STATE OF OHIO  
DEPARTMENT OF TRANSPORTATION  
INTER-OFFICE COMMUNICATION

To John Morrison, District Operations Engineer Attention: W. R. Wright, D.T.E.  
From Robert D. McMillen, Engineer, Bureau of Traffic By: Robert V. Priest  
Subject Installation of an Overhead Flasher at the Intersection of State Route 28 and State  
Route 41 in Ross County.

# — ENGINEERING ORDER —

LOCATION: ROSS CO., SR 28, TOP SR 41

PLAN OF INTERSECTION

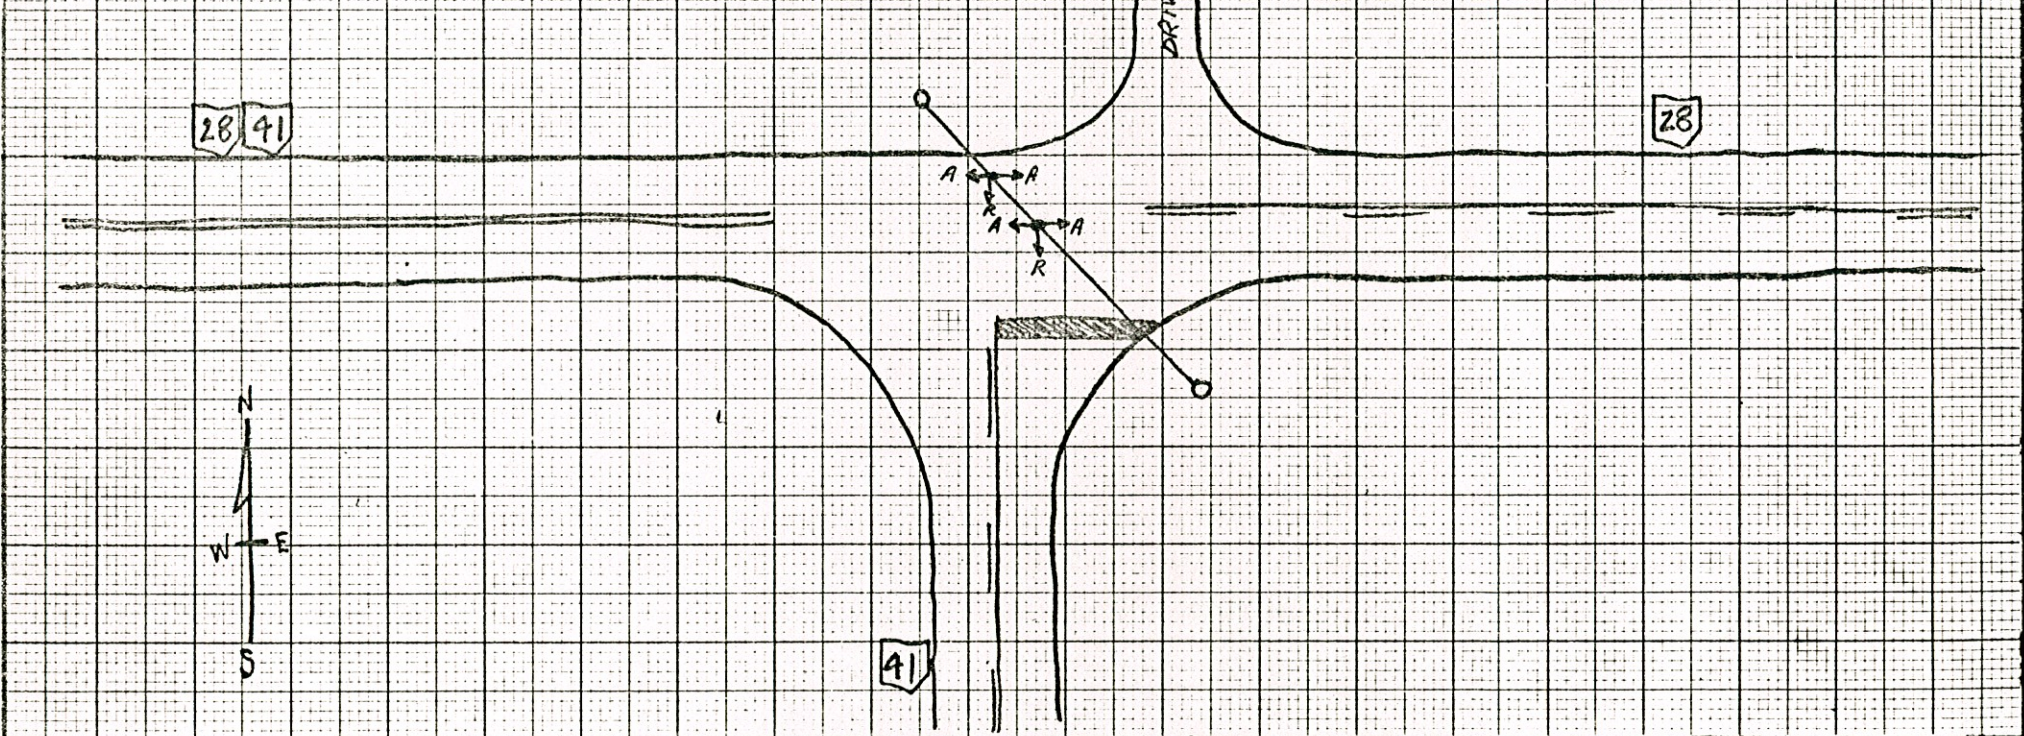
TRAFFIC PROBLEM HIGH SPEED ON SR28 THRU INTERSECTION. INTERSECTION NOT PROMINATE AT CREST OF VERTICAL CURVE FROM ALL APPROACHES. SR28 FROM SR41 DOES NOT LOOK LIKE AN INTERSECTION OR A STOP CONDITION DESPITE ADVANCE SIGNS AND DUAL STOP SIGNS.

REMARKS PROPOSED FLASHER, AMBER TO SR28 FOR AND RED TO SR41, FOR INTERSECTION IDENTIFICATION.

This is in reply to your IOC dated June 5, 1975, regarding the installation of an overhead flasher at the subject location. Please be advised that we concur with this installation and will add it to our signal schedule.
